**ADDENDUM NO. 002
INVITATION FOR BID NO. 25304
Relocation of Winslow Park
T. F. Green Airport**

IFB 25304 – Relocation of Winslow Park, T.F. Green Airport

RIAC CONTRACT NO. 25304

NOTICE TO PROSPECTIVE BIDDERS
ADDENDUM NO. 2

3 WALL SECTION
 A-7 Scale: 3/4" = 1'-0"

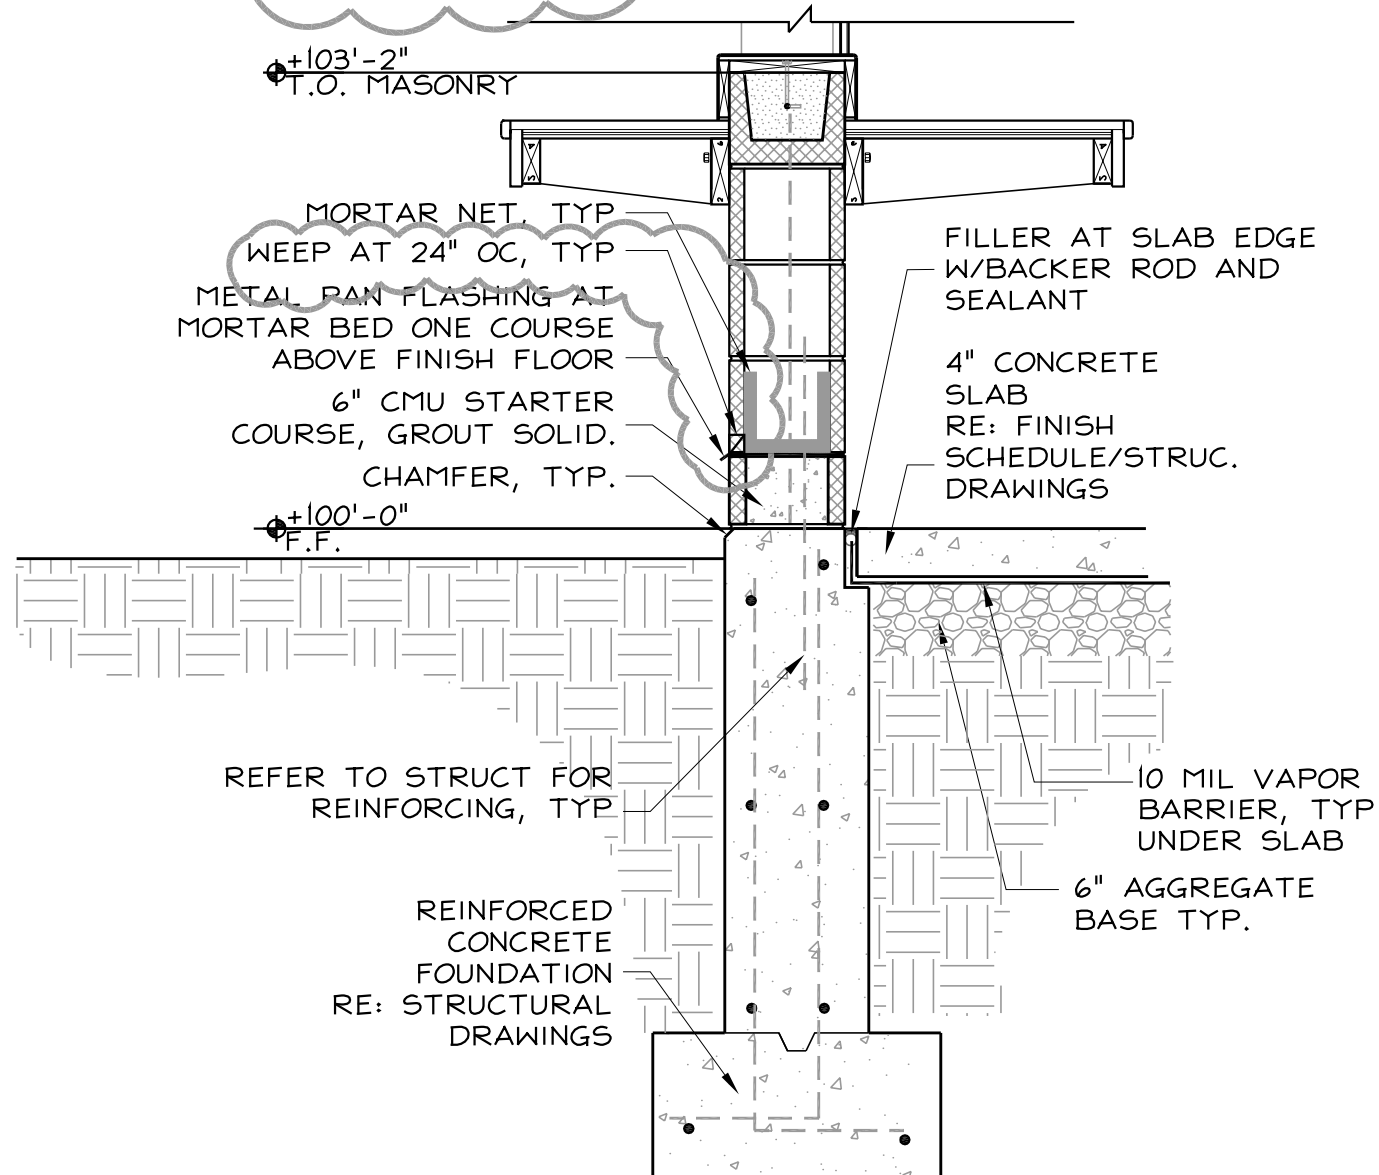
On Sheet A-7, Building/Wall Sections, Delete the Detail 3, “Wall Section,” and Insert the revised Detail 3 “Wall Section,” attached hereto as “Addendum No. 2, Attachment 3”

NOTE:
 INSTALL UPPER MASONRY
 WEEPS AT 32" OC, TYP
 UNDER FIBER CEMENT
 SIDING, TYP
 ALL WEEP TO BE INSECT
 RESISTANCE

1 TYP SIDING DETAIL
 SKA-1 Scale: 1 1/2" = 1'-0"

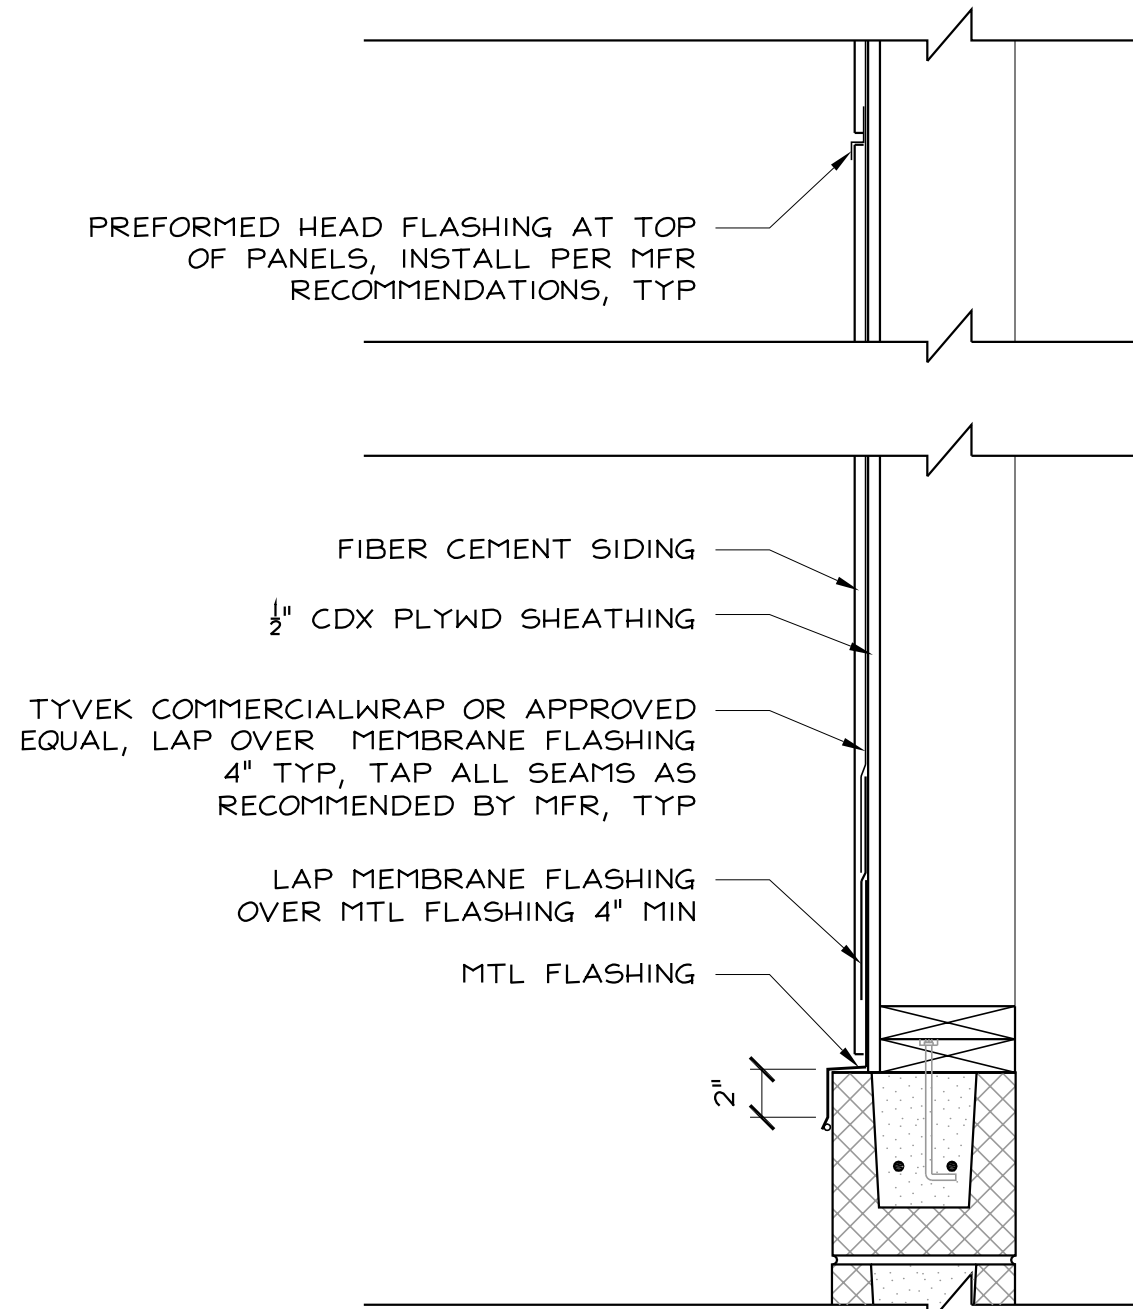
On Sheet A-7, Building/Wall Sections, Insert "Detail 1/SKA-1 Typ Siding Detail," attached hereto as "Addendum No. 2, Attachment 3"

1 SECTION, PRIVACY PARTITION
A-8 Scale: 1-1/2" = 1'-0"

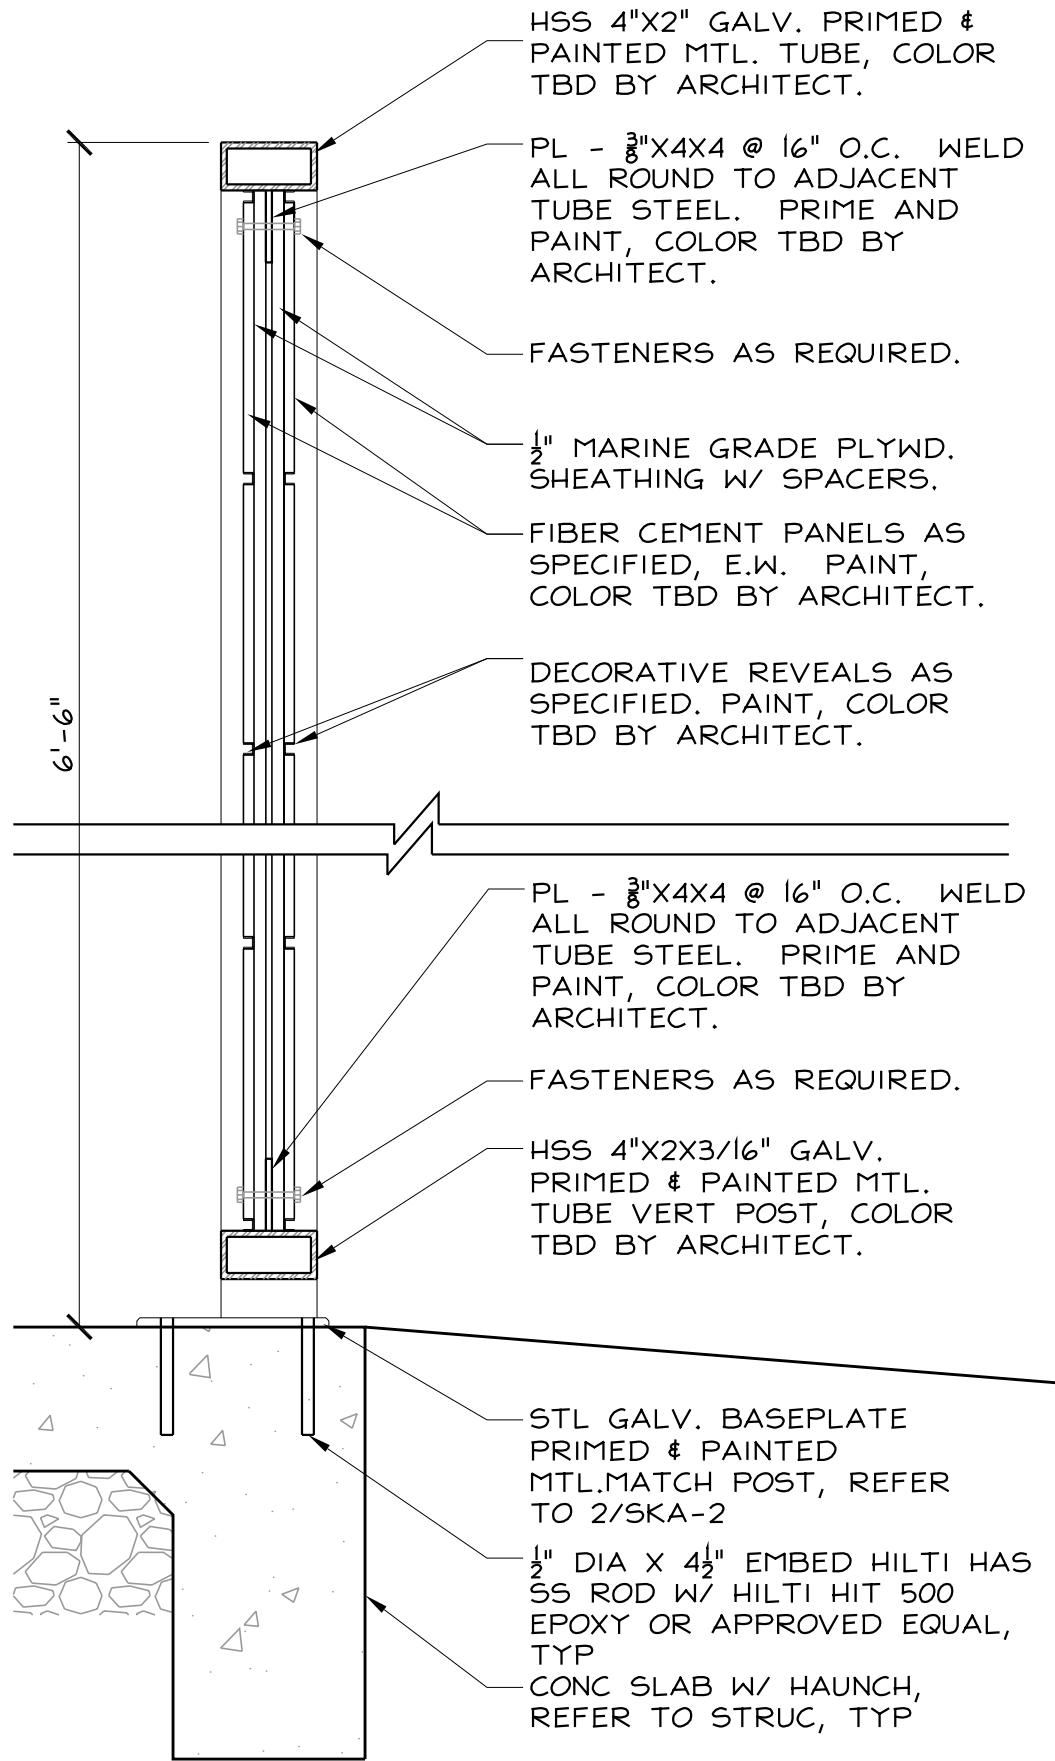
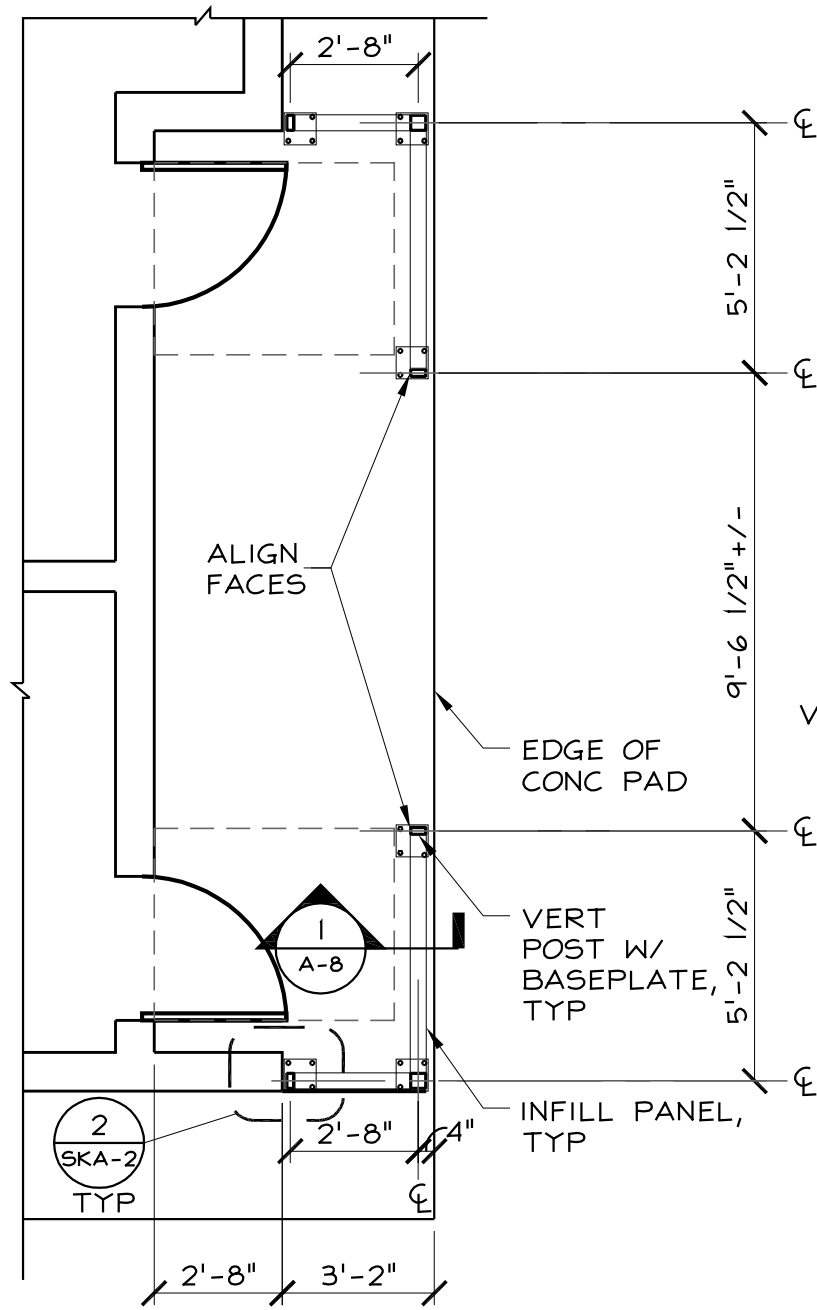
- Q40. Section 1/A-8 PRIVACY PARTITION: What is the wall thickness of the tube steel? How are the partitions supported? Please clarify the layout.
- A40. a. 3/16"

On Sheet A-8, Exterior Details, Delete the Detail 1, "Section, Privacy Partition," and Insert the revised Detail 1, "Section, Privacy Partition," attached hereto as "Addendum No. 2, Attachment 4"

b. Refer to Addendum Item No. 14.
c. Refer to Addendum Item No. 14.
- Q41. Section 08452 Section 1.1 LEED Credits - Is this a LEED project? Daylight Autonomy - Do we need a Daylight Modeling Report? A Daylight Autonomy report has not been done for this project and would take approximately two weeks if one is needed.

1 PRIVACY PARTITION PLAN
SKA-2 Scale: 1/4" = 1'-0"

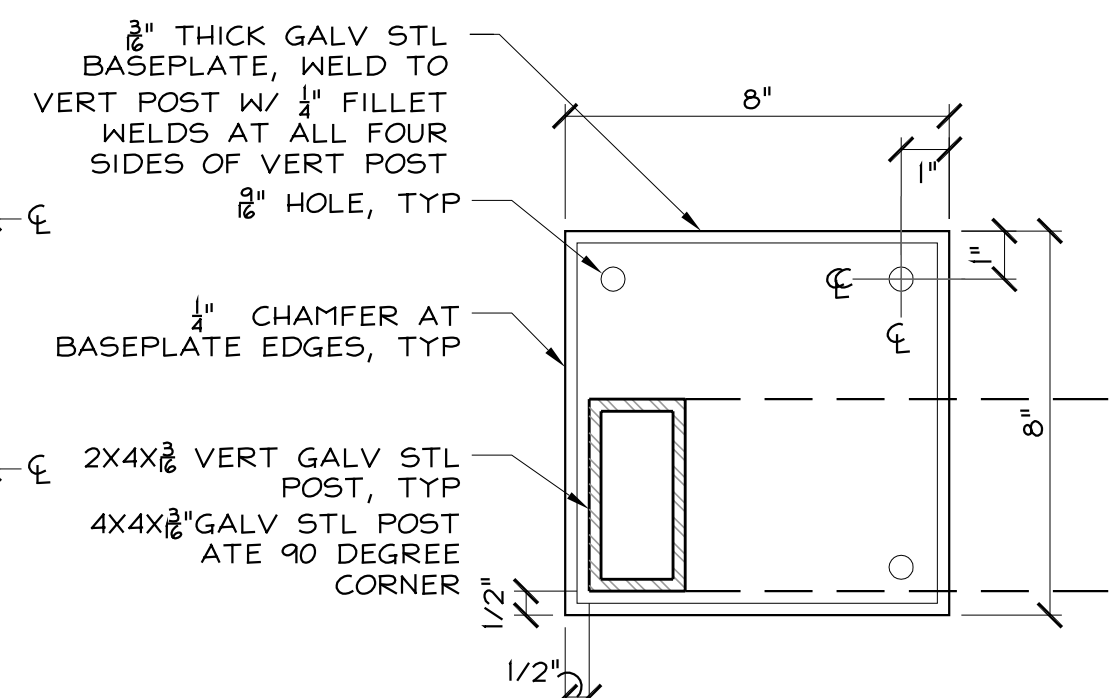
On Sheet A-8, Exterior Details, Insert "Detail 1/SKA-2 Privacy Partition Detail," attached hereto as "Addendum No. 2, Attachment 4"

On Sheet A-8, Exterior Details, Insert "Detail 2/SKA-2 Baseplate Detail," attached hereto as "Addendum No. 2, Attachment 4"

HIGH ROOF FRAMING

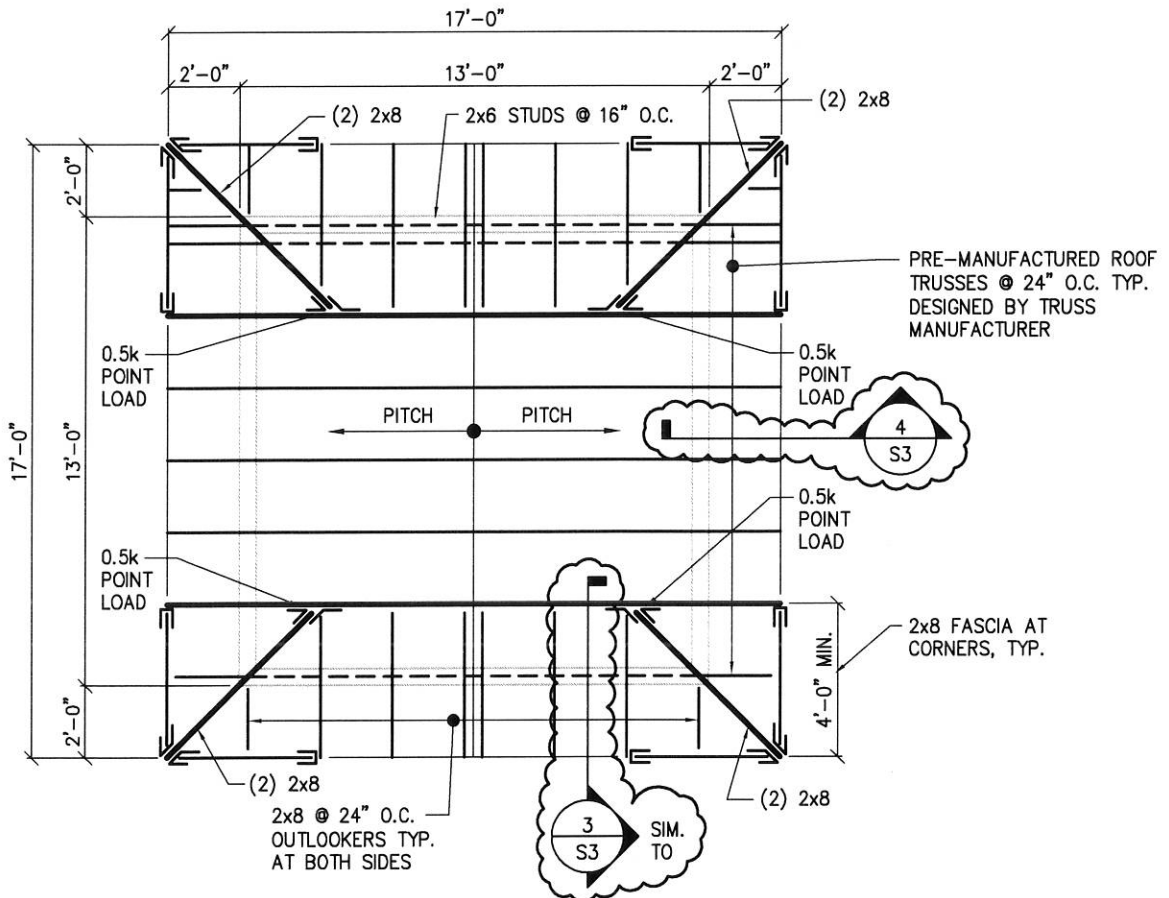
- A34 The contract duration shall remain 380 calendar days. Final completion shall be based upon 380 calendar days from award.
- Q35. The architectural drawings show a gable roof. The roof framing shown on the structural drawings show a hip roof. What is the roof style? Please coordinate the architectural and structural drawings.

On Sheet S-2, Roof Framing Plan & Notes, Delete the detail "High Roof Framing" and Insert the revised "High Roof Framing" detail, attached hereto as "Addendum No. 2, Attachment 5"

- A35. Gable. Drawings are coordinated for gable construction. Refer to all structural drawings for outlooker details at rakes and soffits.
- Q36. Section 06160 calls for the Wall Sheathing; Nominal Thickness: Not less than 3/4 inch and Roof Sheathing; Nominal Thickness: Not less than 3/4". The drawings show 1/2" marine plywood Wall Sheathing and 5/8" Roof Sheathing. Please clarify the sheathing thickness and grades.
